Regulation No. 94

**UNIFORM PROVISIONS CONCERNING THE APPROVAL OF VEHICLES WITH
REGARD TO THE PROTECTION OF THE OCCUPANTS IN THE EVENT OF A
FRONTAL COLLISION**

Proposal for draft amendments to Regulation No. 94- Rev. 1

Submitted by the expert from France

Figure 1: Measurement of V_b , V_1 , V_2

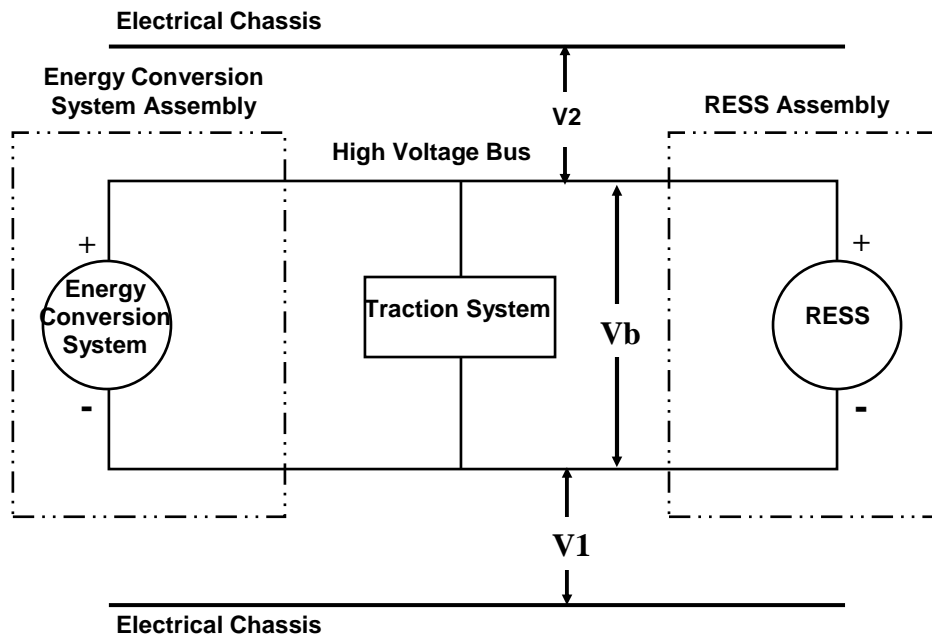
The following instructions may be used if voltage is measured. Prior to the vehicle crash test measure and record the high voltage bus voltage (V_b) (see Figure 1). If V_b is high voltage, conduct the specified vehicle crash test. After the crash test, determine the high voltage bus voltages (V_b , V_1 , V_2) (see Figure 1). [The measurement shall be made after 5 seconds of the vehicle coming to rest after each crash test.]

Figure 2: Measurement of $V_{1'}$

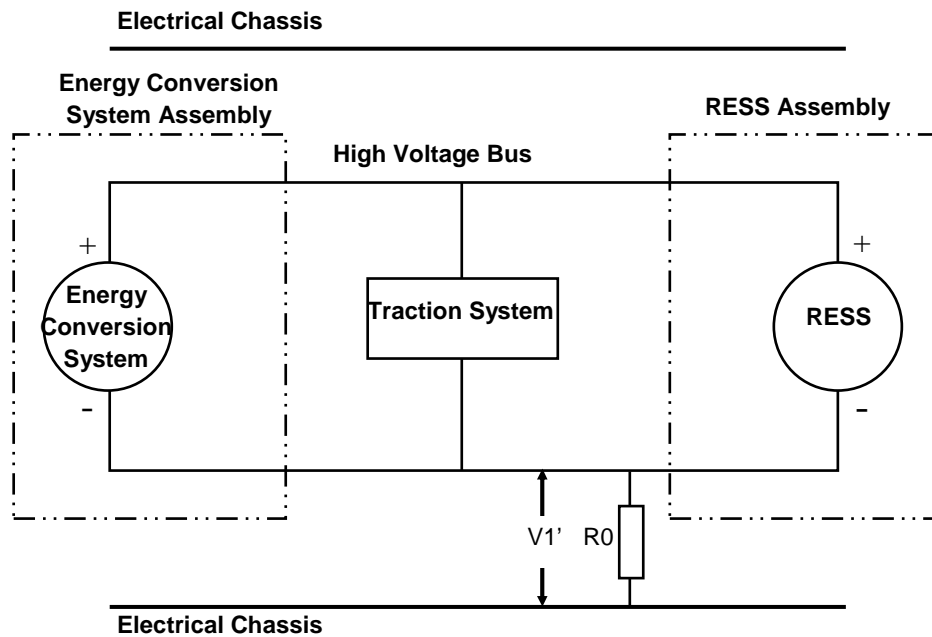
If V_1 is greater than or equal to V_2 , insert a standard known resistance (R_0) between the negative side of the high voltage bus and the electrical chassis. With R_0 installed, measure the voltage ($V_{1'}$) between the negative side of the high voltage bus and the electrical chassis (see Figure 2). Calculate the electrical isolation (R_i) according to the following formula:

$$R_i = R_0 \cdot (V_b / V_{1'} - V_b / V_1) \quad \text{or} \quad R_i = R_0 \cdot V_b \cdot (1 / V_{1'} - 1 / V_1)$$

Figure 3: Measurement of V_2'

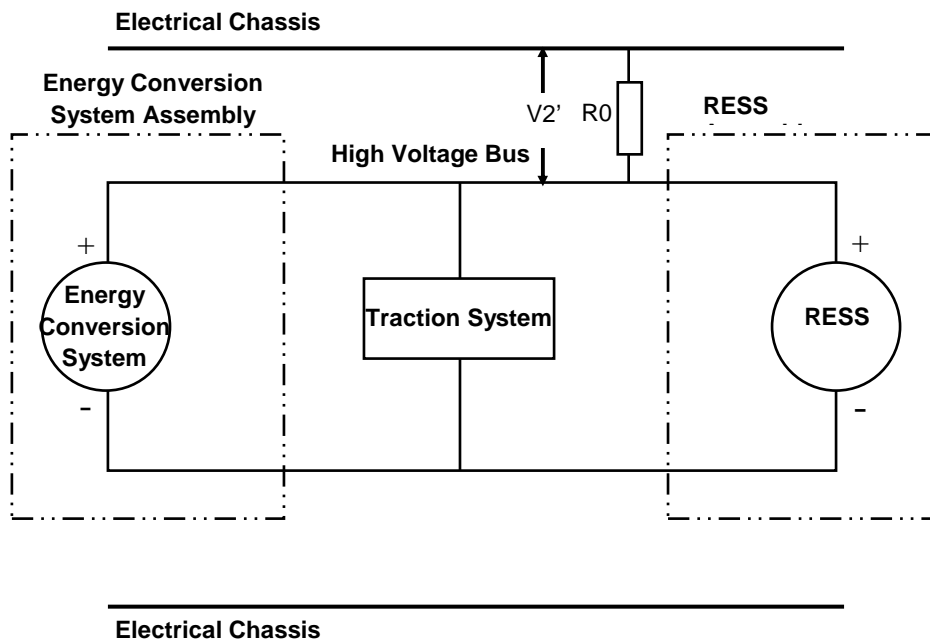
If V_2 is greater than V_1 , insert a standard known resistance (R_0) between the positive side of the high voltage bus and the electrical chassis. With R_0 installed, measure the voltage (V_2') between the positive side of the high voltage bus and the electrical chassis. (See Figure 3). Calculate the electrical isolation (R_i) according to the formula shown. Divide this electrical isolation value (in ohms) by the nominal operating voltage of the high voltage bus (in volts).

$$R_i = R_0 \cdot (V_b / V_2' - V_b / V_2) \quad \text{or} \quad R_i = R_0 \cdot V_b \cdot (1 / V_2' - 1 / V_2)$$

Figure 4: Measurement of high voltage bus energy

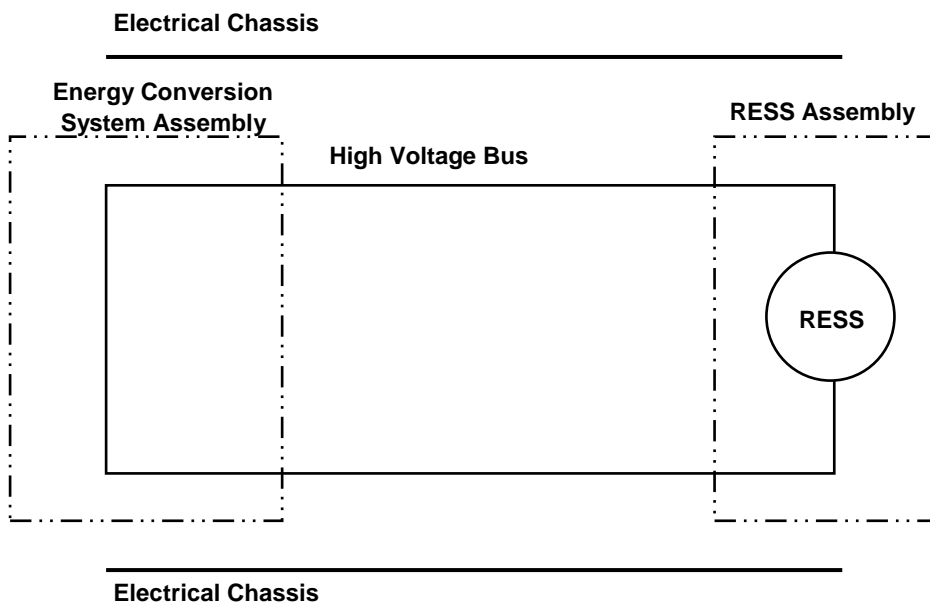
After the vehicle crash determine the high voltage bus energy (see Figure 4). Install switch S1 and known resistance R_e . Close switch S1 and measure and record voltage V_b and current I_e . Integrate the product of these two measurements with respect to time as shown below to obtain total energy.

$$\int_{t_0}^{t_1} V_b \times I_e dt \quad [t_0 = \text{closing S1 after 5 seconds of the vehicle coming to rest} \\ t_1 = \text{to be defined}]$$

1 IPXXB Jointed test finger diameter 12; 80 length Dimensions in millimetres

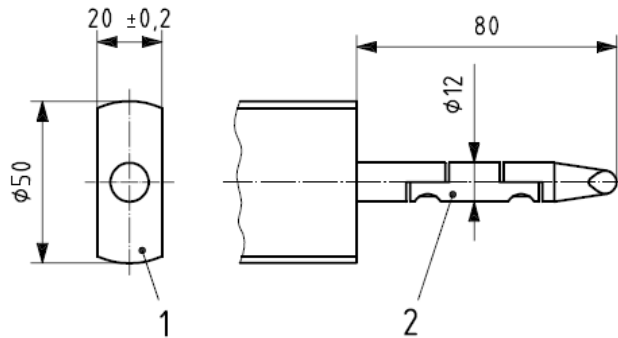
The jointed test finger may penetrate over its full length of 80 mm but shall not contact the hazardous parts, even when its joints are bent at any optional angle (up to 90° from its axis) and are brought into any possible position. The stop face ($\text{Ø}50\text{ mm} \times 20\text{ mm}$) shall not pass through the opening.
